## SERVICE LETTER No. L 138-Rev.4

**MODEL AFFECTED:** Z 242 L aircraft, S/N: 0682, S/N 0685, S/N 0745

**SUBJECT:** Aircraft manufacturer instructions for detected cracks and defects and repair instructions.

*Fig. No. 1 (S/N 0682)*

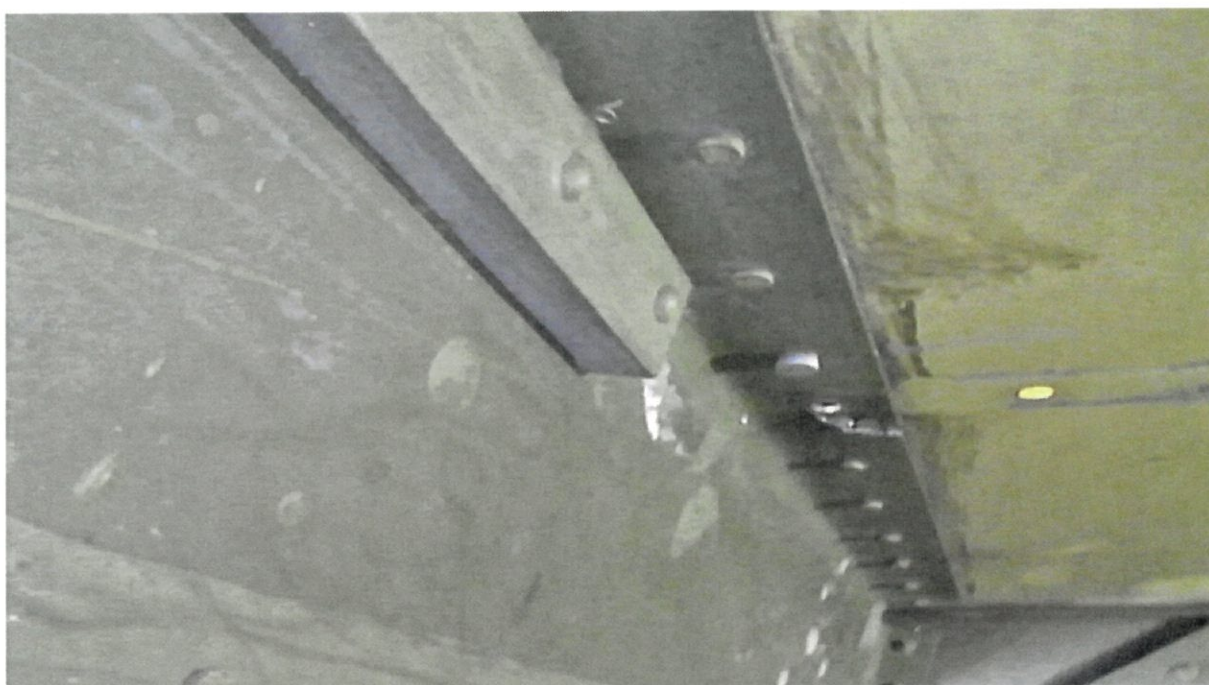
- 1) Aft spar of the left wings (see Fig. 1 and No. 2 and No. 3 and No. 4 and No. 5).

- Repair the aft spar cracks as described on pages 4-43 of the above-mentioned document. The cracked rib will be strengthened by the plate in accordance with the sketch provided by the operator's maintenance facility (see Enclosure No. 1)
- The rivets used for reassembly and plate reinforcement will be provided by ZLIN AIRCRAFT. The rivets must be positioned in accordance with the enclosed sketch (Enclosure No. 1) – see annotations made by ZA.
- All existing rivet holes must be re-drilled for new rivet size to assure their proper alignment.

ENCLOSURE No. 1 of Service Letter L138-Rev.4

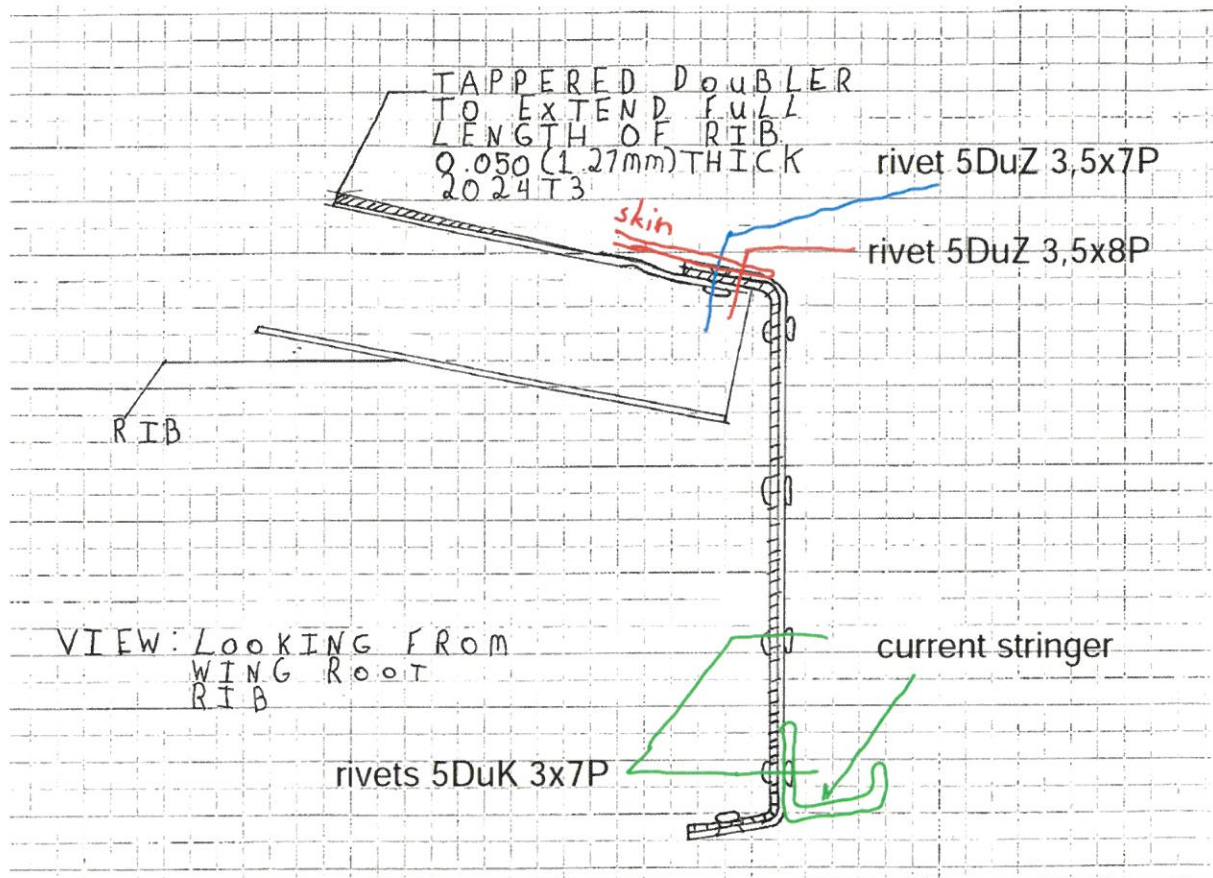
**NOTE:** use the rivets provided by Zlin Aircraft

- New holes for rivets (ČSN 02 2302.5, size 2,6) will be drilled in accordance with the sketch provided by the maintenance facility and annotated by the manufacturer.
